Device **TC23x**
Marking/Step **ES-AB, AB**
Package **see Data Sheet**

10209AERRA

This Errata Sheet describes the deviations from the current user documentation.

Figure 1 Message buffer transfer from Message RAM to OBF

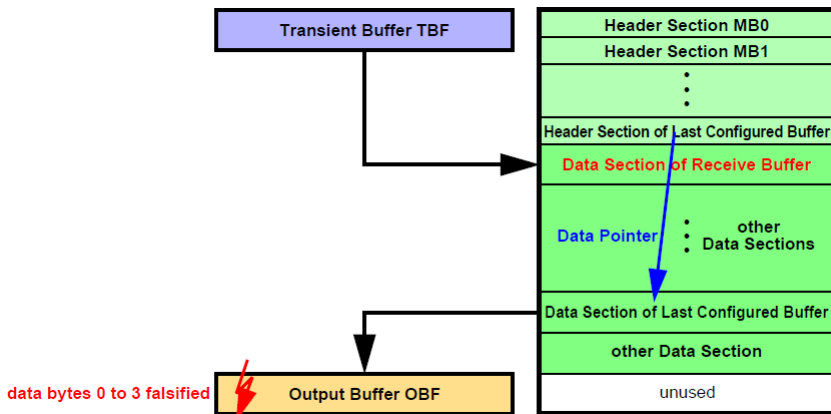
a) When a message is transferred from the Last Configured Buffer in the Message RAM to the OBF and **PLC** = 127 it may happen, that at the end of the transfer the OBF word on address 00h (payload data bytes 0 to 3) is overwritten with unexpected data (see [Figure 1](#)).

Figure 2 Message buffer transfer from IBF to Message RAM

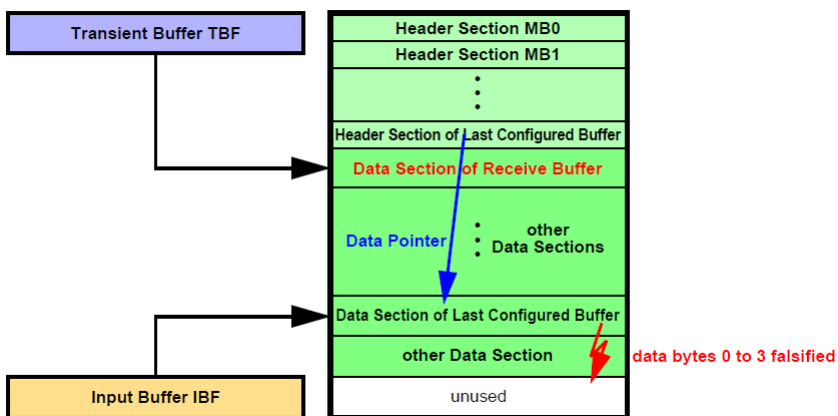
b) When a message is transferred from IBF to the Last Configured Buffer in the Message RAM, it may happen, that at the end of the transfer of the Data Section one additional write access overwrites the following word, which may be the first word of another message's Data Section in the Message RAM (see [Figure 2](#)).

Figure 3 Message RAM Configurations

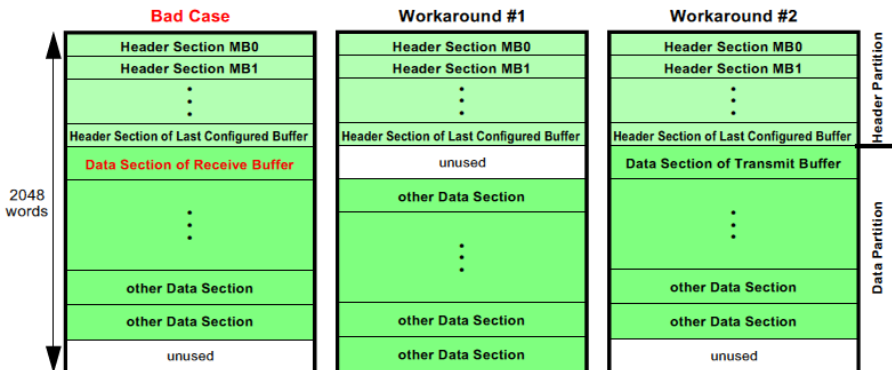
The erratum is limited to the case when (see [Figure 3](#) “Bad Case”):

2) Ensure that the Data Section directly following the Header Partition is assigned to a transmit buffer.

Figure 4 Example sequence showing how registers ETRRx may be filled with “Error Free” addresses

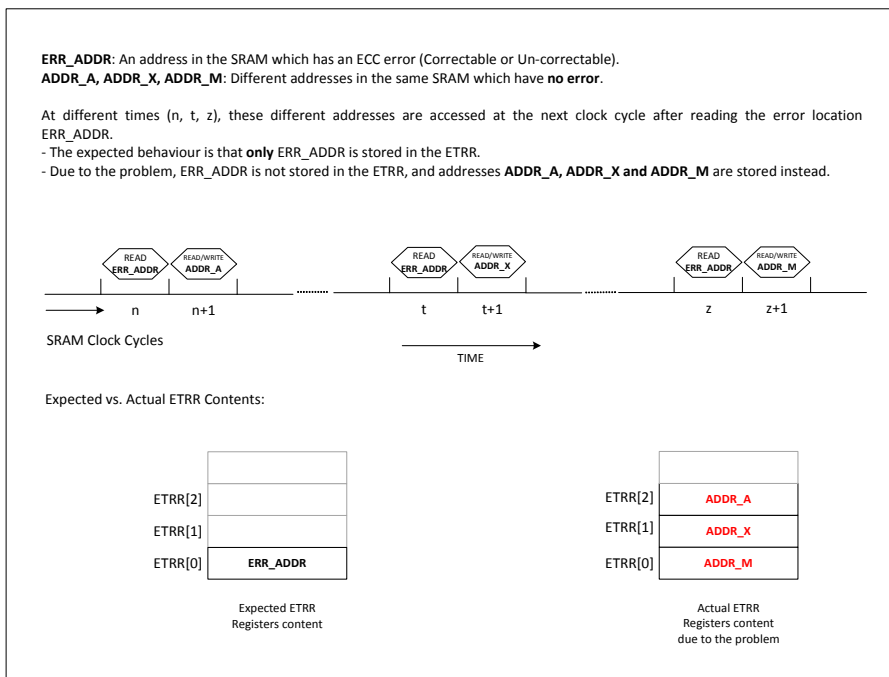
When such a consecutive access sequence (read from ERR_ADDR followed by read/write of different address(es)) happens multiple times, registers ETRRx are filled with addresses that have actually no error – and the SRAM address which actually has an error is not stored indeed. **Figure 4** shows such an example scenario.

The consequence of the scenario explained in **Figure 4** is that a single error in the SRAM – example just one correctable error at a location ERR_ADDR – can result in registers ETRRx getting filled with fault-free address, and thus potentially even triggering an ETRR overflow.

Figure 5 Recommended Software Handling - Flowchart

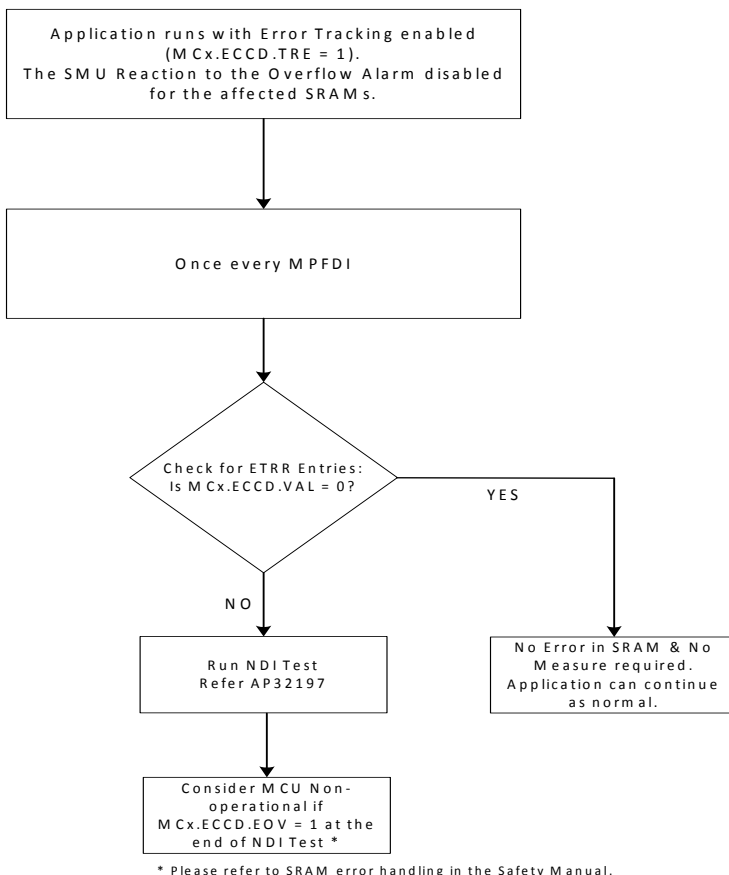
A flowchart of the recommended software handling is shown in [Figure 5](#).

If there is at least one valid ETRR entry (i.e. $MCx.ECCD.VAL \neq 0$) then the software shall run a Non-Destructive-Inversion (NDI) Test on the affected SRAM. Please refer to application note AP32197 (AURIX™ Memory tests using the MTU) for an example regarding running this test.

At the end of this test, if an ETRR overflow is detected ($MCx.ECCD.EOV = 1_B$) then the MCU shall be considered non-operational. Refer to section on Correctable SRAM Error handling in the Safety Manual.

Figure 7 Transmitter - losing CAN FD node

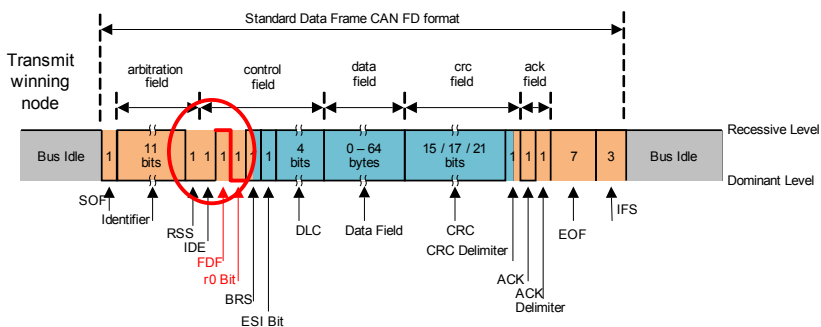
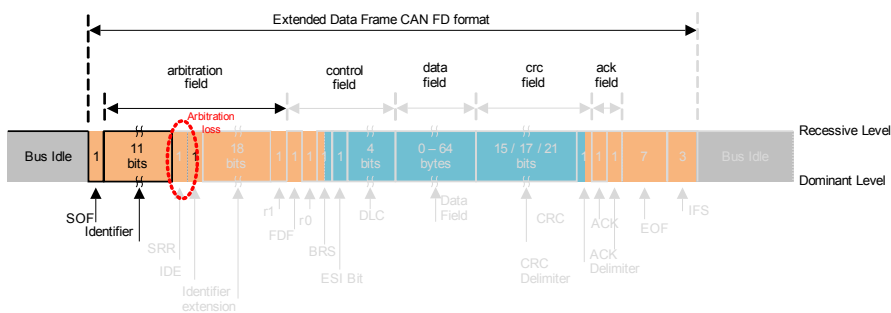
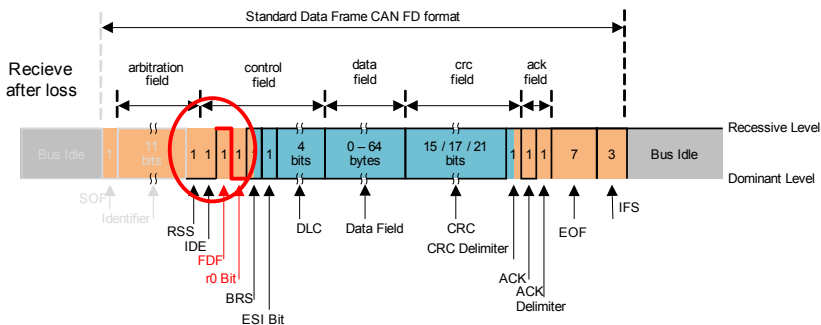
If a transmitter is losing arbitration late (e.g. in an extended frame - see [Figure 6](#) the node which wins arbitration and [Figure 7](#) the transmitting node loosing

arbitration), then the FDF bit to res bit is the last chance to synchronize to the winning node (here as a receiver **Figure 8** the same node as in **Figure 7**). A timing offset will occur between the now receiving node and the actual transmitter.

The device is producing more error frames within a network than a device with a hardsync at the FDF bit.

Figure 13 Short Serial Message, Serial Data Encoding over 16 messages

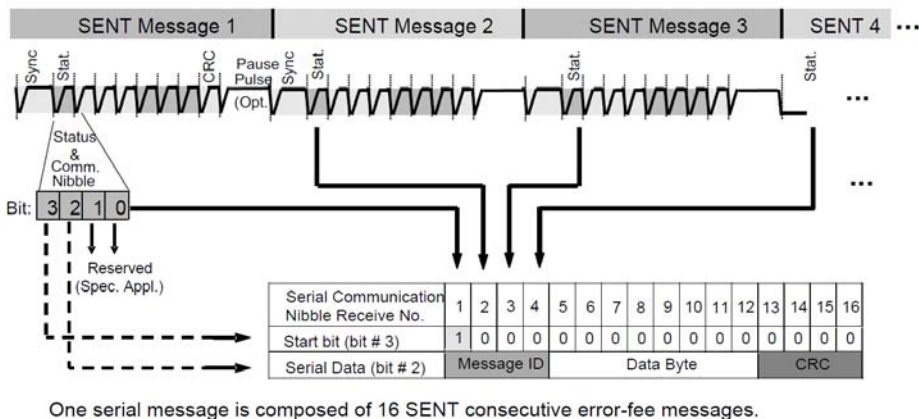
Figure 13 shows a corrected version of this figure.
